**MEMORANDUM**

**Subject:** U District Rezone Potential Amendments for Consideration

**Attachment 1: Potential Amendments for PLUZ Committee Consideration**

# MAP OF PROPOSED AVE REZONE

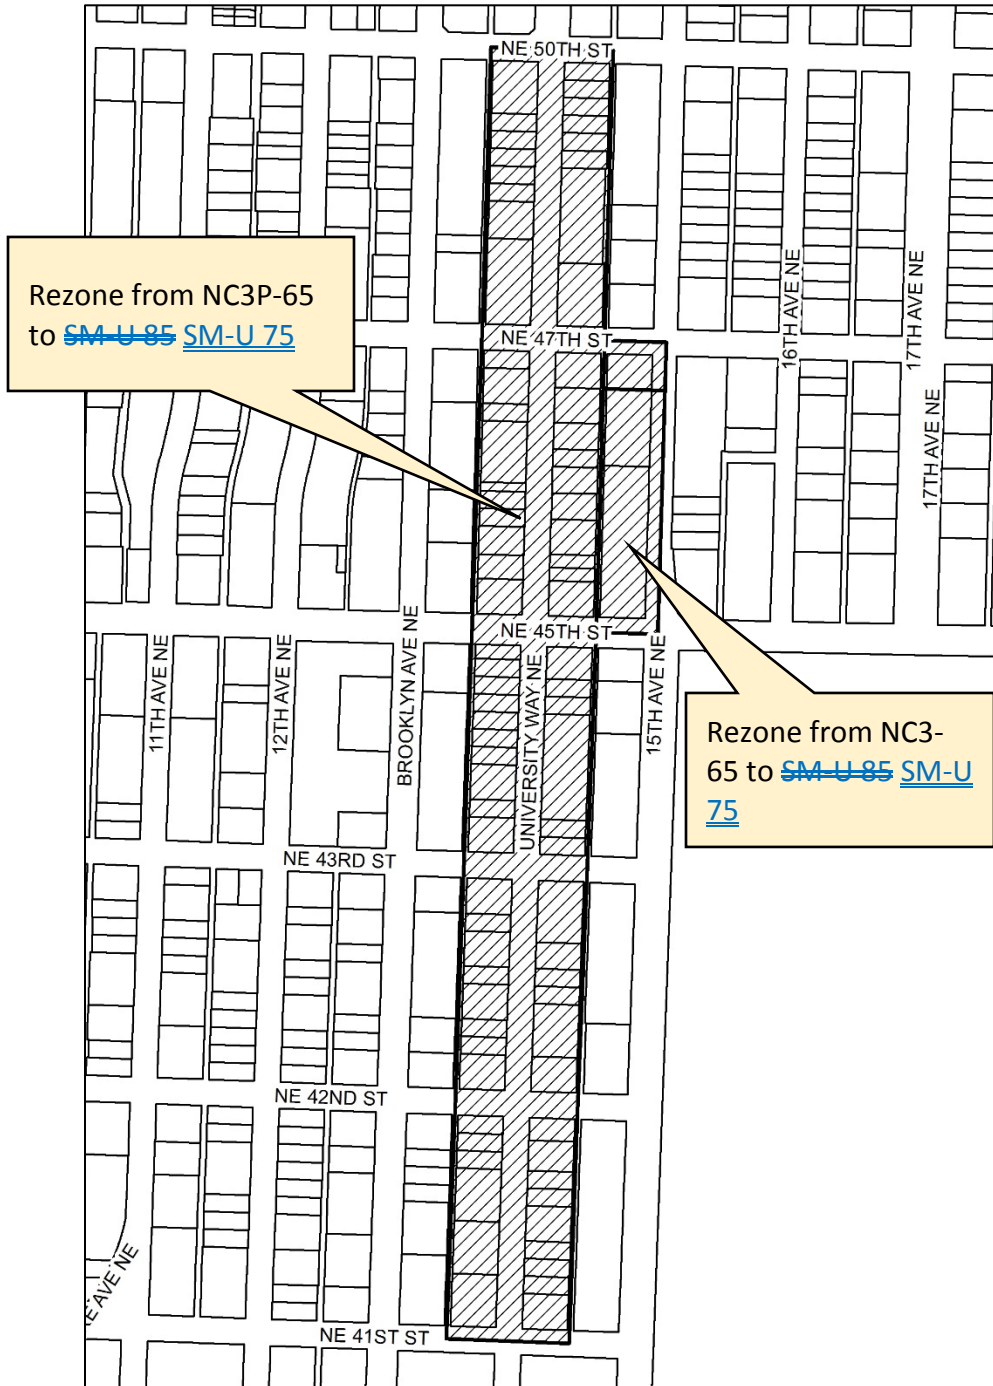
Amendment to rezone the Ave (University Way NE) and one adjacent half-block to Seattle Mixed-University District with a 75 foot height limit (SM-U 75) from Neighborhood Commercial 3 with a Pedestrian designation and 65 foot height limit (NC3P-65), removing the base FAR limit and the associated incentive zoning requirements.

- the Official Land Use Map on Page 60, 78, and 79 to reflect the new zone (see map at end of this attachment)
- subsection 23.48.620.A to incorporate FAR requirements for the SM-U 75 zone (page 78 of [Council Bill \(CB\) 118862](#))
- subsection 23.48.620.B to remove the incentive zoning requirements in the SM-U 75 zone (page 80 of CB 118862)

**Exhibit A for 23.48.040**  
**Area ((Where Transparency)) where transparency and ((Blank Facade Requirements Apply)) blank facade requirements apply to ((Structures)) structure**

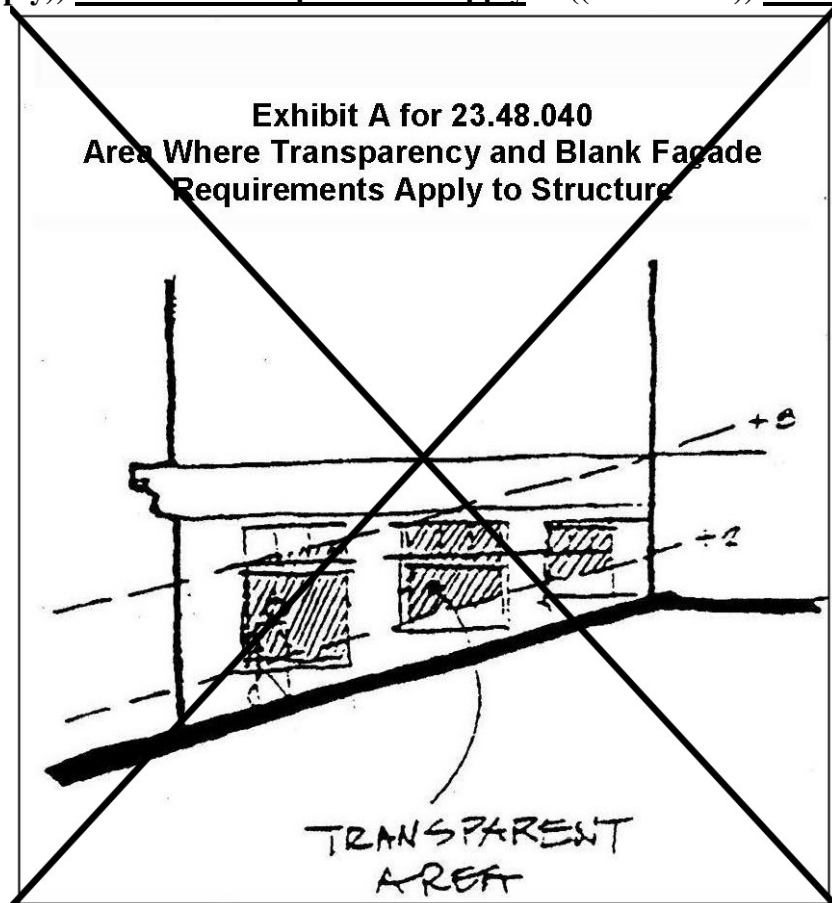
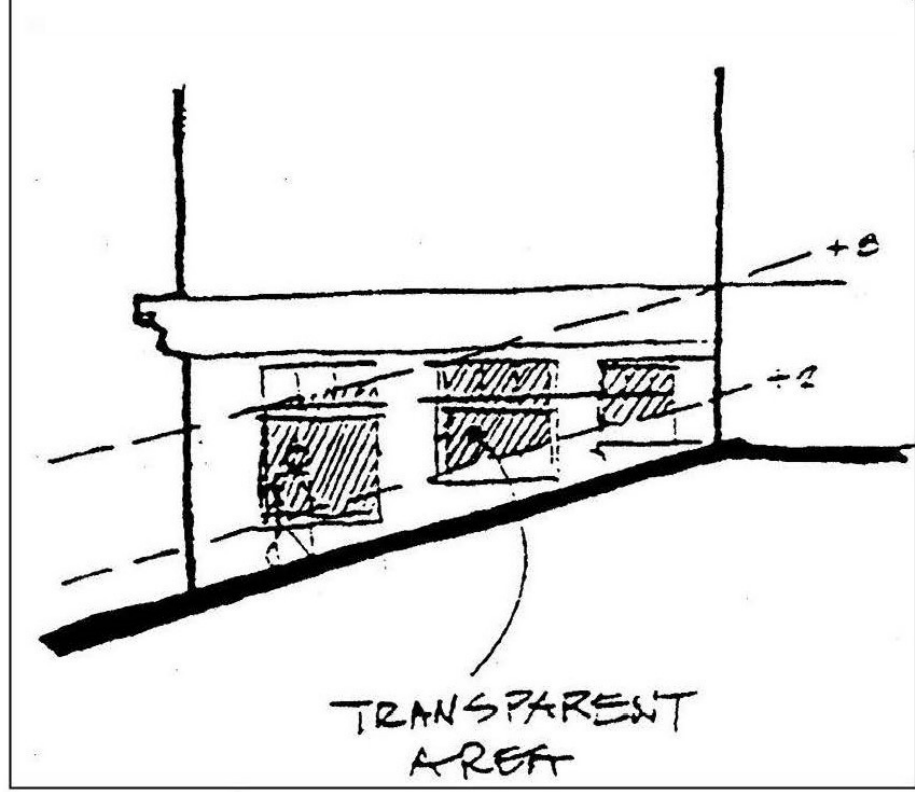
B. Transparency and blank facade requirements. The provisions of this subsection 23.48.040.B apply to the area of a street-facing facade between 2 feet and 8 feet above a sidewalk, as shown on ((€))Exhibit A for 23.48.040((€) pursuant to subsection 23.48.040.B.1)), but do not apply to portions of a structure in residential use or, within the SM-U district, to portions of a structure in use as a light rail transit station.
